PB# 87-15

**Goodwin Associates
(3-Lot Sub.)**

TOWN OF NEW WINDSOR
PLANNING BOARD
REVIEW COMMENTS

PROJECT NAME: Goodwin Subdivision
PROJECT LOCATION: Lake Road (West Side)
NW #: 87-15
22 September 1987

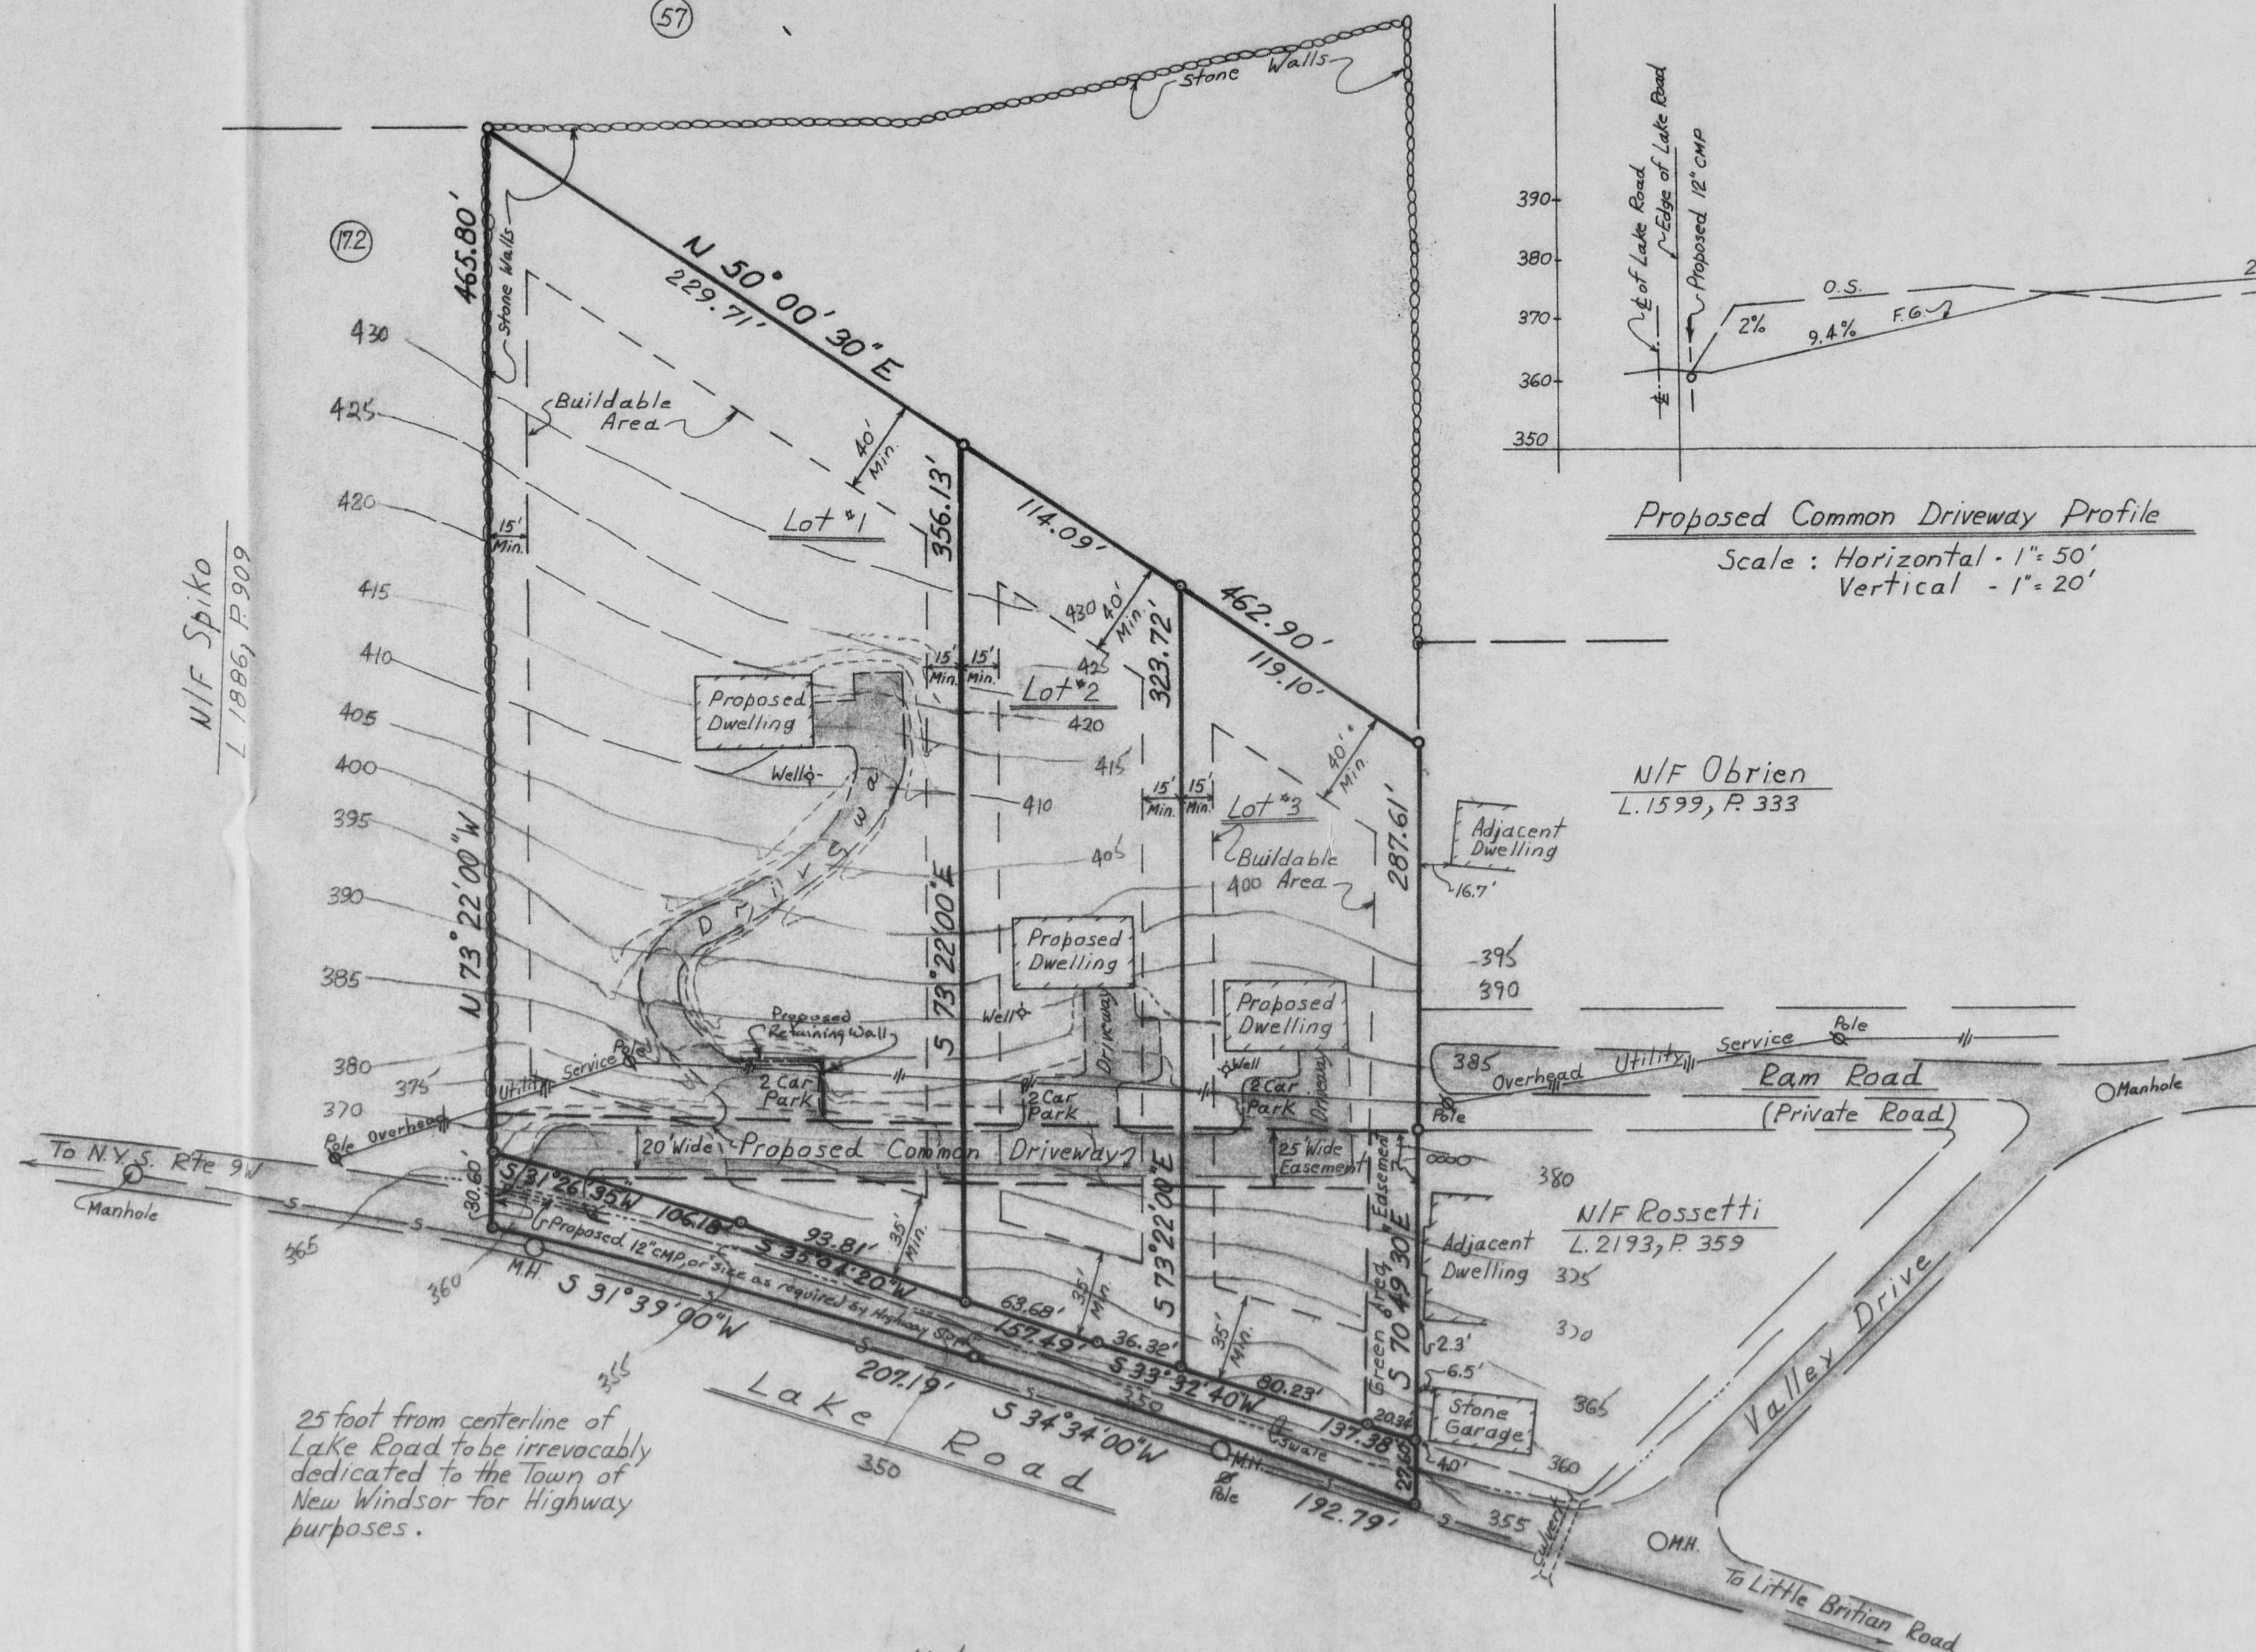
2. The Applicant's Surveyor has revised and re-prepared the Plan such that the existing and proposed topography is more clear. The common driveway for the three (3) lots has been revised to result in slopes varying from 5% to 9.8%. Overall the common driveway configuration and slope appears acceptable.

3. The Board should require that some adjustments be made to the "two car park" area and driveway to the proposed dwelling on Lot No. 1. The parking area as shown has a slope of nearly 36% and the first portion of the driveway has a slope of approximately 33%. It is my recommendation that at least the parking area and lower portion of the driveway should have a reasonable slope.

4. The indicated 12" C.M.P. as proposed for the proposed common drive should indicate "or size as required by the Highway Superintendent". Note No. 4 of the Plan should be revised based on the common driveway and this requirement.

5. The Board should note that a restriction has been placed on the further subdivision of Lot No. 1, per Note No. 10 on the Plan.

The design of the subdivision could be vastly improved by utilizing
Ram Road, shown as a public road on the tax maps, rather than a separate private
drive. In so doing, the parcel in question could be more efficiently subdivided,
the curbcut along Lake Road would be eliminated and the subdivision would be better
coordinated with surrounding preexisting development and roads.

Ram Road off of Valley Drive is not accessible for fire fighting
apparatus. The common driveway which is 20 feet wide is not
acceptable. Additionally there are three (3) other houses which are
not accessable for fire fighting apparatus at this time.

It is recommended that Valley Drive be regraded by the Town so
that fire fighting apparatus can make the grade or that a second
roadway be made from Lake Road to tie into Ram Road. All roadway
widths to be a minimum of 34 feet.

- a. The Plan should indicate that the subdivision is in the R-4 Zone, not the R-3 Zone.
 - b. A note should be added indicating that it is the Owner's responsibility to coordinate relocation of the overhead utility lines.
 - c. The typical driveway profile shall include dimensions, as applicable for conformance with the driveway slopes to the Town requirements.
 - d. The Plan should clearly be identified as a Subdivision Plan not a "Survey of Lands".
3. The Board should discuss with the Applicant, the configuration of the access to the three (3) lots; specifically the fact that the driveway slopes are up to 28%.
4. The Plan as currently submitted, is not acceptable for approval from an engineering standpoint.

3). Based on the revised Zoning Map, it is my understanding that the property is located in the R-4 Zone, not the R-3 Zone as indicated.
